UNITED STATES PATENT AND TRADEMARK OFFICE

APPLICATION NO.	FILING DATE	FIRST NAMED INVENTOR	ATTORNEY DOCKET NO.	CONFIRMATION NO.
09/750,504	12/26/2000	Junji Yoshida	6635-60104	6968

<b>Office Action Summary</b>	<b>Application No.</b>	<b>Applicant(s)</b>	
	09/750,504	YOSHIDA ET AL.	
	<b>Examiner</b>	<b>Art Unit</b>	
	Quyen P. Leung	2828

F I G. 1

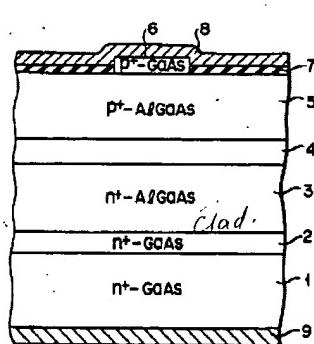
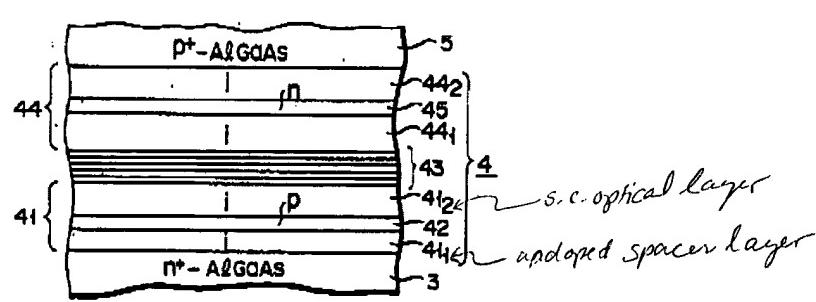
2. Claims 1-3, 5-15, 17-21, 23-29 are rejected under 35 U.S.C. 102(b) as being anticipated by McIlroy et al (4,701,774). McIlroy et al discloses the claimed invention. Figures 1 and 2 illustrate a semiconductor laser device comprising a doped semiconductor cladding layer (3), a semiconductor optical layer (41<sub>2</sub>); and an undoped semiconductor spacer layer (41<sub>1</sub>) positioned between the cladding layer (3) and the optical confinement layer (41<sub>2</sub>). Note further the substrate (1), the semiconductor active layer (43) for generating light, a semiconductor upper optical confinement layer (44<sub>1</sub>); a p-doped semiconductor upper cladding layer (5); and electrodes (8,9) for current injection to the device. See col. 6 lines 60-63 for the suggestion of InP and InGaAsP.

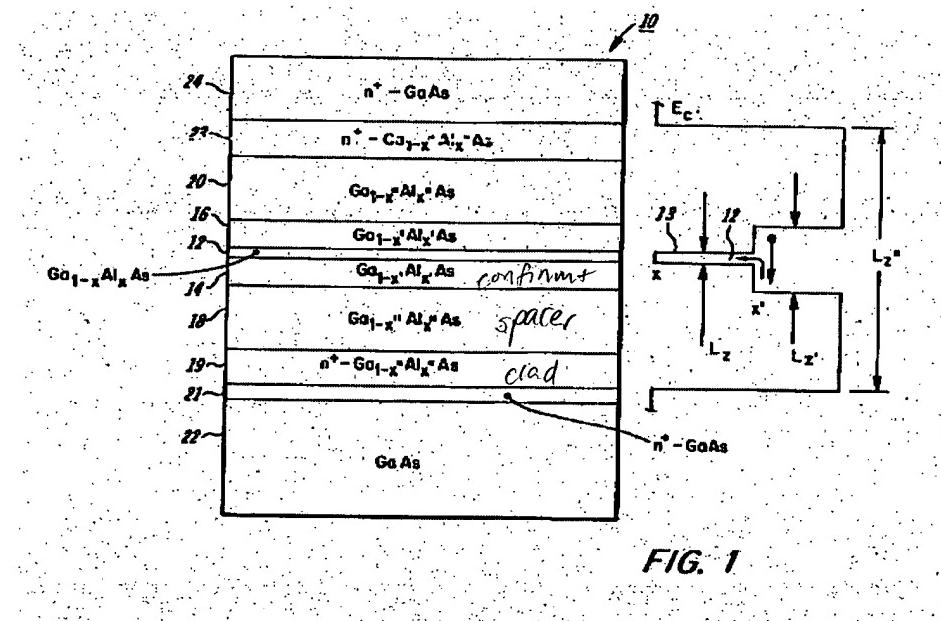
3. Claims 1-4, 6, 11, 20-22, 28-30 are rejected under 35 U.S.C. 102(b) as being anticipated by Burnham et al (4,585,491). Burnham et al discloses the claimed invention.

Figure 1 illustrates a semiconductor laser device (10) comprising a doped semiconductor cladding layer (19), a semiconductor optical confinement layer (14); and an undoped semiconductor spacer layer (18) positioned between the cladding layer (19) and the optical confinement layer (14). Note further the substrate (22), the semiconductor active layer (12) for generating light.
